Access Compliance Report

Public Rights-of-Way

(Curb Ramps)

Intersection ID: 6211	Main Street: BILLINGS_PARK_DR	Cross Street: WYNDHAM_POINTE_DR	Location: S
ADA ID: 69336BCC7D0D	Ramp Type: Perp	Initial Pass/Fail: Fail	Overall Compliance: No
Severity Score: 12.5			
Codes/Mitigation Info/Possible Solution		Field Measurements/Component Compliance

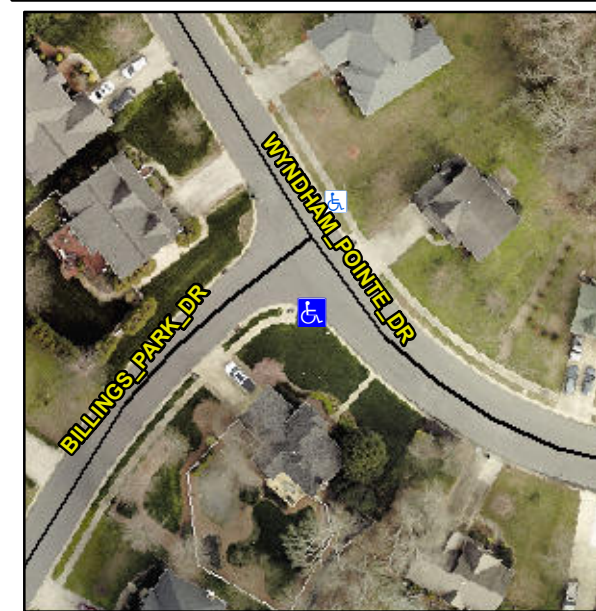
R304.2.2

Compliance	Description	Data	Compliance	Description	Data
N/A	Ramp Length (in)	47.0	No	Ramp Slope (%)	8.9
Yes	Ramp Width (in)	48.0	Yes	Ramp XSlope (%)	0.3
N/A	Flare Type LT	N/A	N/A	Flare Type RT	N/A
N/A	Flare Slope LT (%)	N/A	N/A	Flare Slope RT (%)	N/A
N/A	Flare Traversable LT?	N/A	N/A	Flare Traversable RT?	N/A
N/A	Landing Length (in)	N/A	N/A	DWS Provided?	N/A
N/A	Landing Width (in)	N/A	N/A	DWS Contrast?	N/A
N/A	Landing Slope (%)	N/A	N/A	DWS Length (in)	N/A
N/A	Landing X Slope (%)	N/A	N/A	DWS Full Width?	N/A
N/A	Landing Curb? (Y/N)	N/A	N/A	DWS Offset (in)	N/A
N/A	Shared Landing?	N/A			
N/A	Gutter Ponding?	N/A	N/A	Gutter Slope (%)	N/A
N/A	Gutter Lip Ht (in)	N/A	N/A	Gutter X Slope (%)	N/A
N/A	Painted X Walk1?	No	N/A	Painted X Walk2?	N/A
	X Walk 1 Direction	To NE		X Walk 2 Direction	N/A
N/A	X Walk 1 Width (in)	N/A	N/A	X Walk 2 Width (in)	N/A
	X Walk 1 Slope (%)	1.0		X Walk 2 Slope (%)	N/A
	X Walk 1 X Slope (%)	0.9		X Walk 2 X Slope (%)	N/A

Remove & Replace Entire Ramp.
